Item Name: Crosstube Assembly, Mid Fwd

DART AEROSPACE LTD	Work Order: 108683
Description: Crosstube Assembly, Mid Fwd	Part Number: D206-667-147
Inspection Dwg: D206-667-147 Rev: A	Page 1 of 2

DART AEROSPACE LTD HAWKESBURY, ONTARIO, CANADA	
DRAWING NO. D206-667-147	REV. A SHEET 1 OF 4
TITLE CROSSTUBE ASS'Y (206L MID FWD)	SCALE NTS

DRAWING NO. D206-667-147	TITLE CROSSTUBE ASS'Y (206L MID FWD)	REV. A	DART AEROSPACE LTD ENGINEERING ORDER		D.E.O. NO. D206-667-147-A-1	SHEET NO. SHEET 1 OF 1	SCALE NTS
DRAWN <i>qp</i>	CHECKED <i>ADS</i>	MFG. APPR. <i>BS</i>	APPROVED <i>MD</i>		DE APPR. <i>#4</i>		
DATE 11.07.15	DATE 11.07.20	DATE 11.07.21	DATE 11.07.21		DATE 11.07.21

DETAIL P
BONDING STRAP INSTALLATION 2 PL

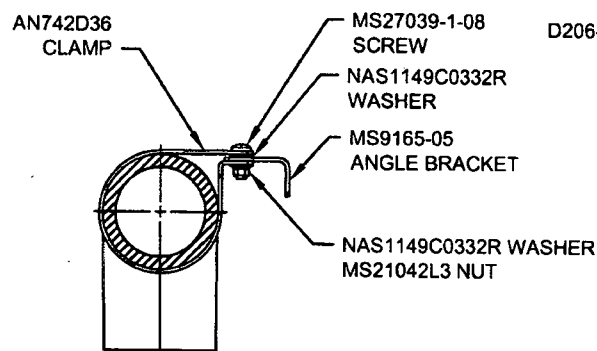
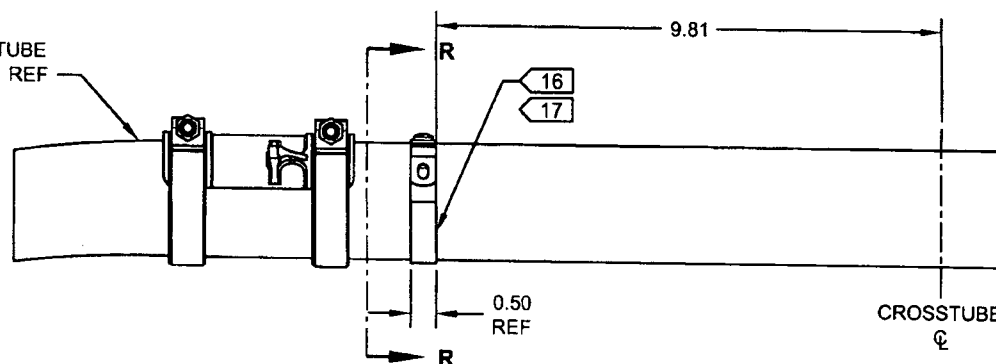
PURPOSE:

ADD ELECTRICAL GROUNDING STRAP

CHANGE:

- 16) MASK AREA UNDER CLAMP PRIOR TO PAINTING
- 17) SEAL EDGES WHERE AN742D36 CLAMP MEETS WITH THE CROSSTUBE USING SIKAFLEX-241/-291 OR MIL-S-8802 CLASS B2 OR PROSEAL 890 SEALANT
- 18) PERFORM RESISTANCE CHECK TO ENSURE MAX RESISTANCE IS 10 MILLIOHMS

ITEM	QTY -147	PART NUMBER	DESCRIPTION
1	X	D206-667-147	CROSSTUBE ASSEMBLY (206L MID FWD)
10	2	AN742D36	CLAMP
11	2	MS9165-05	ANGLE BRACKET
12	2	MS21042L3	NUT (OR MS21042-3)
13	2	MS27039-1-08	SCREW
14	4	NAS1149C0332R	WASHER (OR AN960C10L)
